TO: DEVELOPMENT REVIEW BOARD **DATE:** August 21, 2003

SUBJECT: CASE 30-DR-2003

PROJECT NAME: Hilton Garden Inn **LOCATION:** 8550 E Princess Drive

Stipulations for Case: Hilton Garden Inn 30-DR-2003

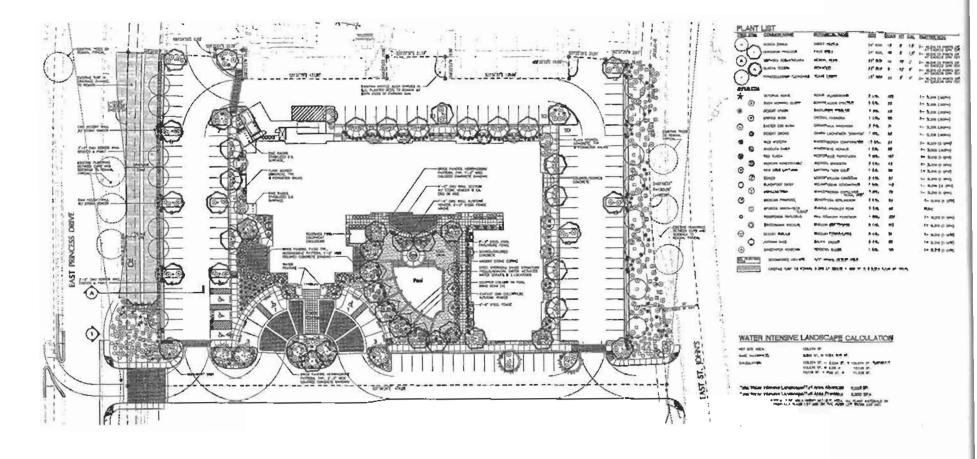
DRB STUDY SESSION: The DRB reviewed this project at the May 8th Study Session. The DRB had comments regarding the proposed colors for the building, which included muted rose and taupe tones. The applicant was directed to provide crisper colors and variety to brownish warm tones. The DRB also indicated a concern regarding the reddish roof color. The applicant has responded to the DRB comments by revising the color palette of the building. The proposal now includes a greenish roof color and tan, taupe and rose building colors. The ledgestone base includes earthy tan and green tones.

- Architectural elements, including dimensions, materials, form, color, and texture, shall be constructed to be consistent with the building elevations submitted by Todd and Associates, Inc. with a date of 7/29/03.
